AL/98/17/HH

PLAN-019935

Proposal: Single storey pitched roof extension at rear and side.
Site: 1 Manser Villas, Westergate Street, Westergate, Aldingbourne, PO20 3QY.
AL/98/17/HH

Screen Print

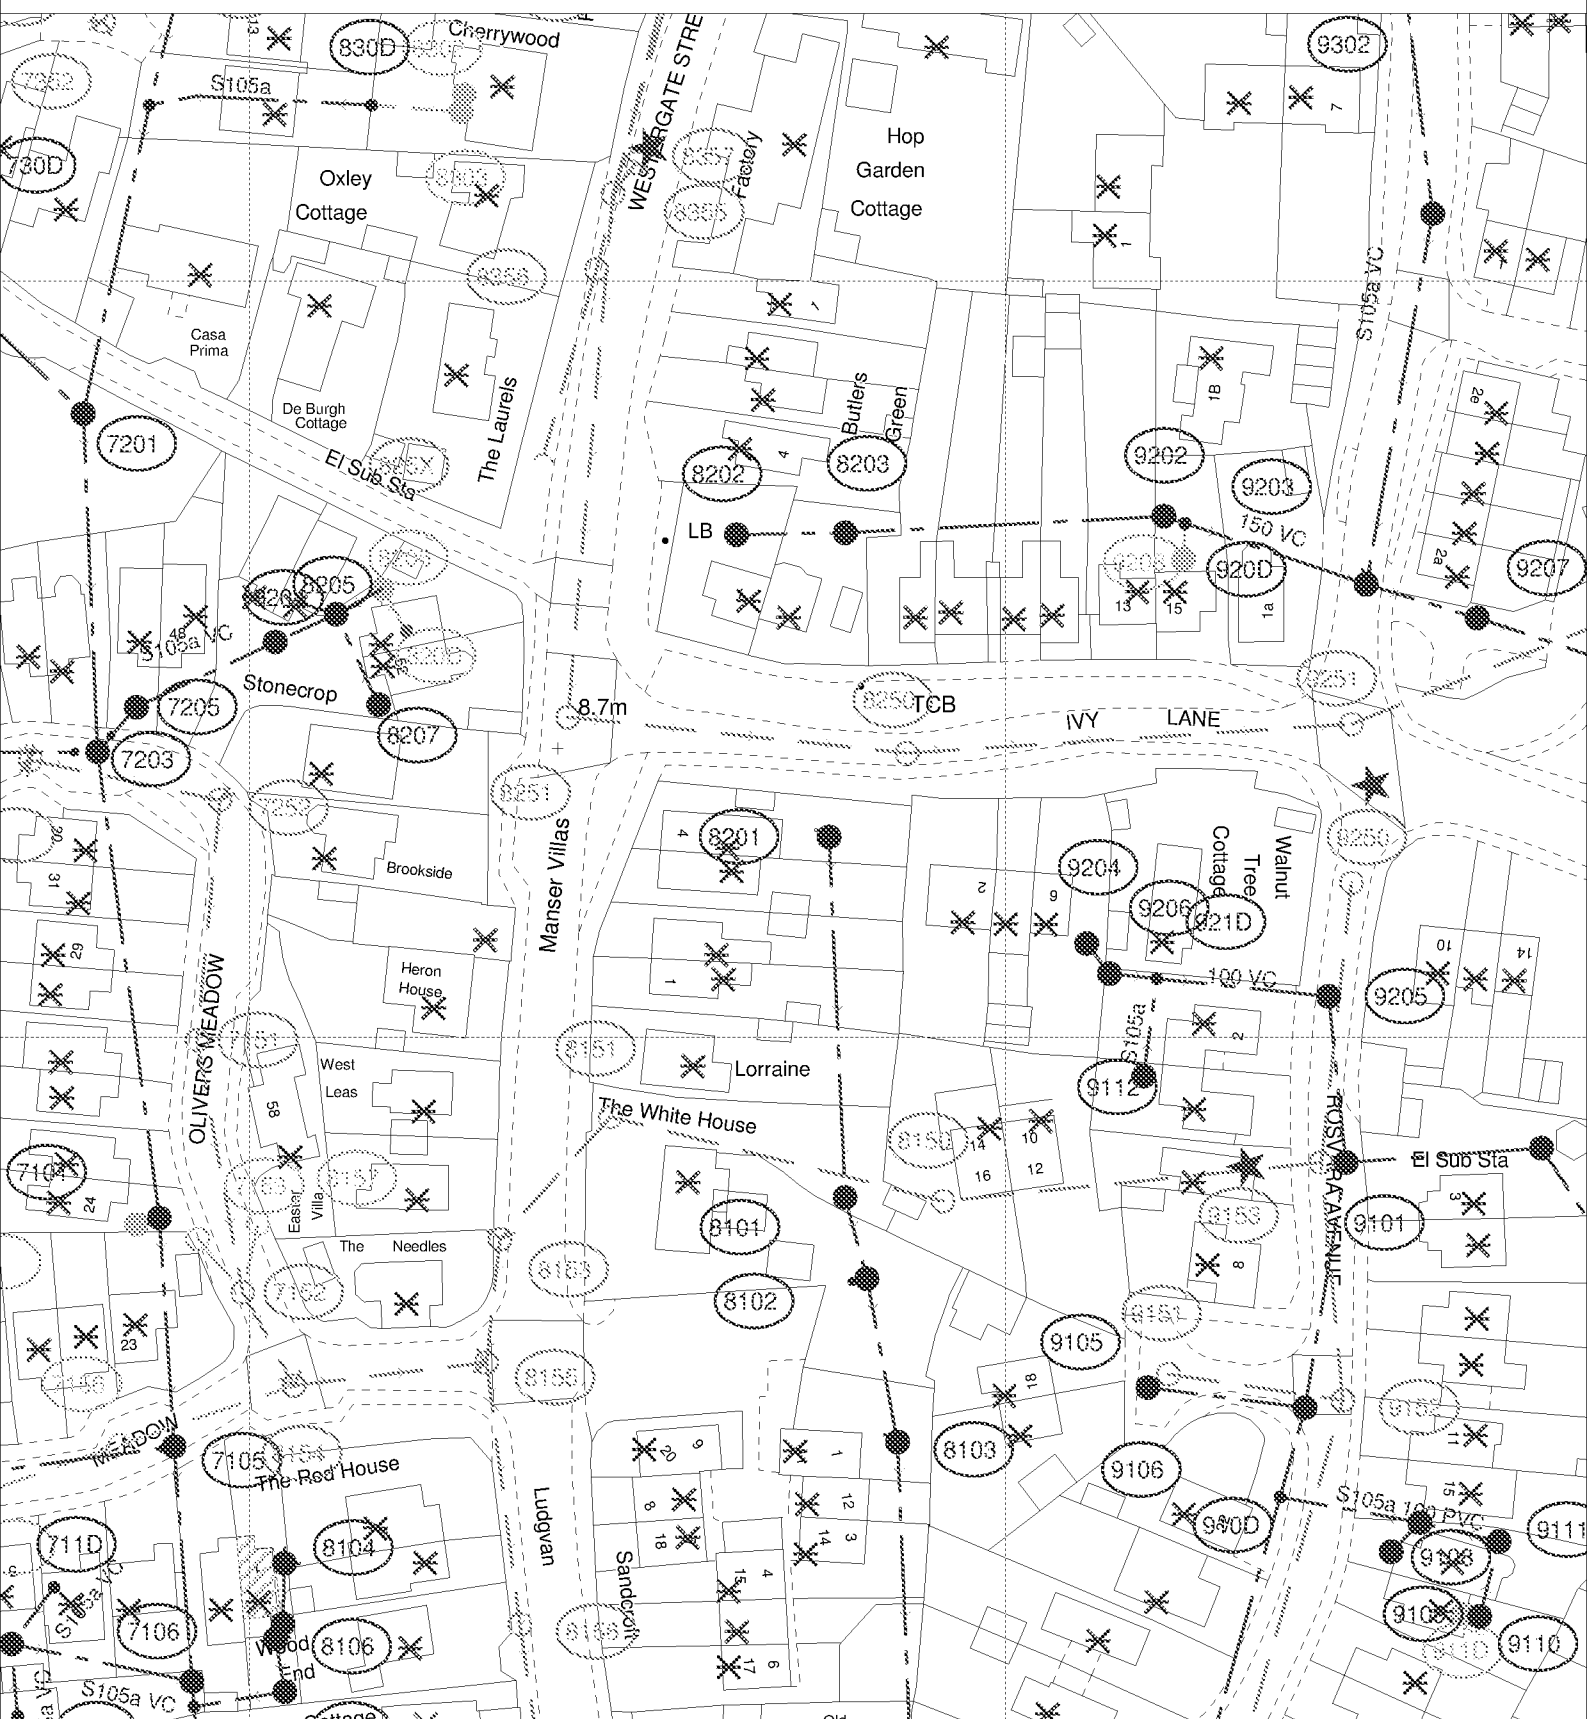
Please find attached a plan of the sewer records showing the approximate position of a public foul sewer within the site. The exact position of the public sewers must be determined on site by the applicant.

No development or new tree planting should be located within 3 metres either side of the centreline of the public sewer and all existing infrastructure should be protected during the course of construction works.

No new soakaways should be located within 5 metres of a public sewer.
